# NOTICE OF PROPOSED CHANGE TO A RENEWABLE ENERGY PROJECT

**Project Name:** ZEP Wind Farm Ganaraska

**MOE Reference Number:** 2482-96DPGE

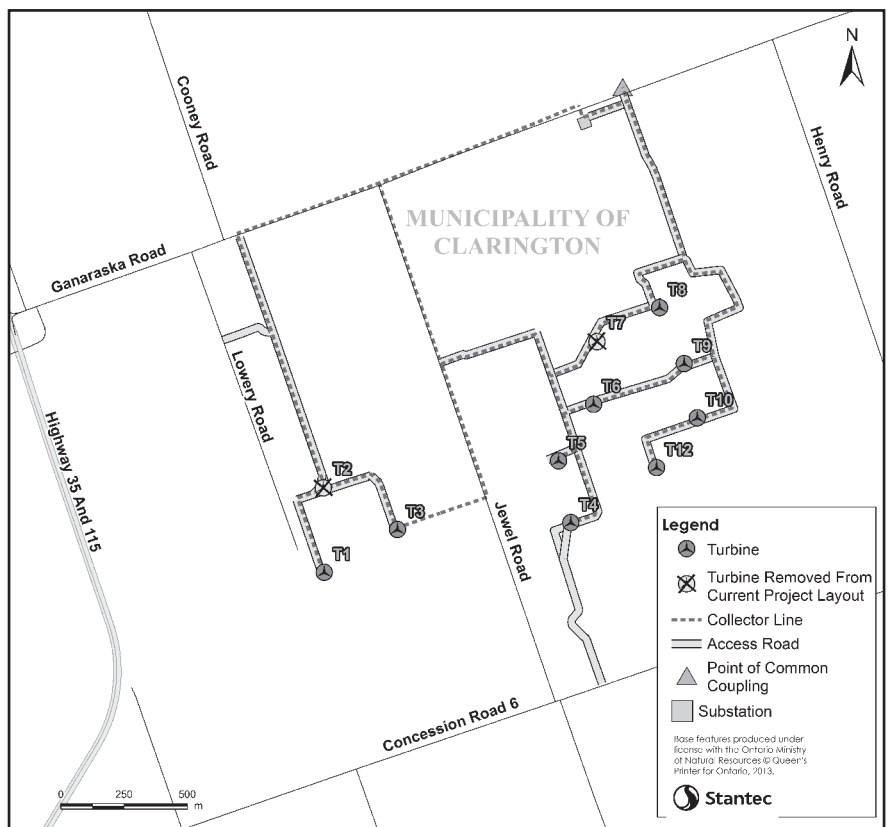
Following consultation with the Ministry of the Environment and Climate Change during the REA review process, a Noise Assessment Report was prepared. To ensure compliance with the 40dBA noise limit requirements, the proponent has opted to remove turbines T2 and T7 from the Project (see map adjacent). The resulting 9 turbine layout has a reduced nameplate capacity of 17.60 MW, down from 20 MW, including several units operating in a de-rated noise mode. The revised layout will meet the 40 dBA noise limit at all non-participating receptors in the area. The locations for the remaining turbines, and the substation, remain unchanged.
